Subject: Response to Nuclear Regulatory Commission Request for Additional Information
Re: Alternative Source Term (TAC No. MD9921)
Cooper Nuclear Station, Docket No. 50-298, DPR-46

**Response to Nuclear Regulatory Commission Request for Additional Information
Re: Alternative Source Term (TAC No. MD9921)**

Cooper Nuclear Station, Docket No. 50-298, DPR-46

Figure 1 Suppression Pool pH with SLC Injection following DBA-LOCA

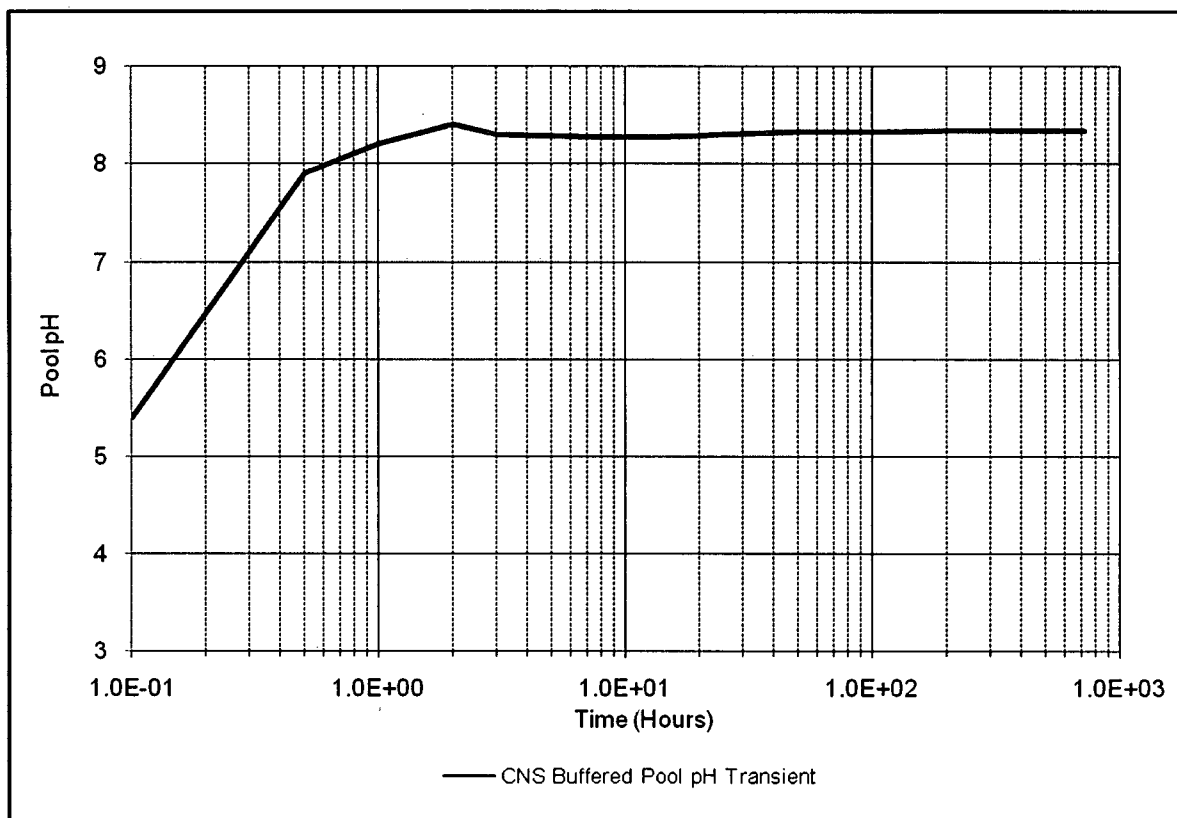
Provide a list and description of components being added to your Title 10 of the Code of Federal Regulations Section 50.49 (10 CFR 50.49) program due to this LAR. Confirm that these components are qualified for the environmental conditions they are expected to be exposed to.

Under DBA-LOCA conditions, significant quantities of acid are generated. Injection of sodium pentaborate decahydrate ($\text{Na}_2\text{B}_{10}\text{O}_{16}\cdot 10\text{H}_2\text{O}$) solution from SLC is credited with buffering the acidity and maintaining pH of the suppression pool inventory above 7.0 for the duration of the DBA-LOCA. Chemical composition of the suppression pool is representative of containment spray conditions after the spray system is manually initiated 10 minutes into the DBA LOCA. Figure 1 reflects the pH profile of the suppression pool following a DBA-LOCA with SLC injection.
